Providence City Plan Commission

December 12, 2023

AGENDA ITEM 6 ■ 150 PITMAN STREET

OVERVIEW

Ground floor and roof plan

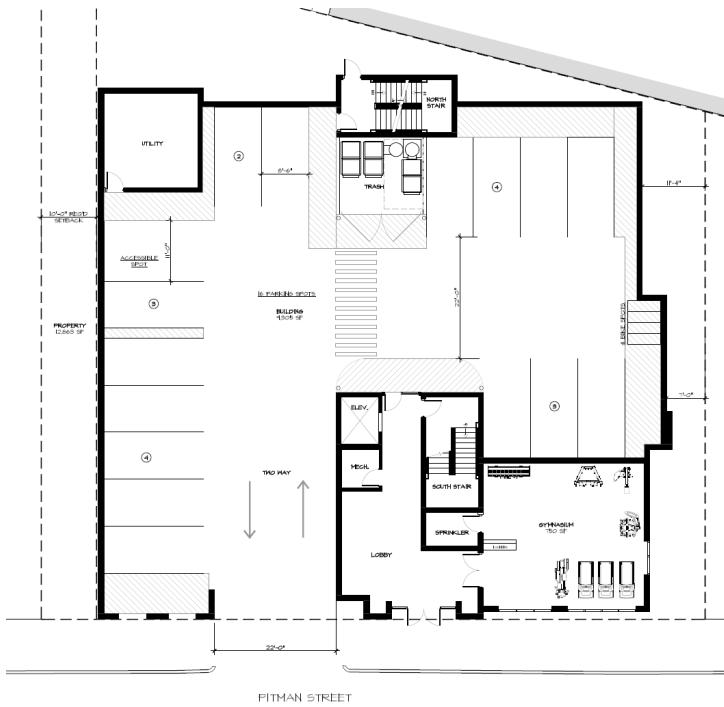
The roof plan indicates that a gathering space consisting of seating with plantings will be provided adjacent to the mechanical/utility area.
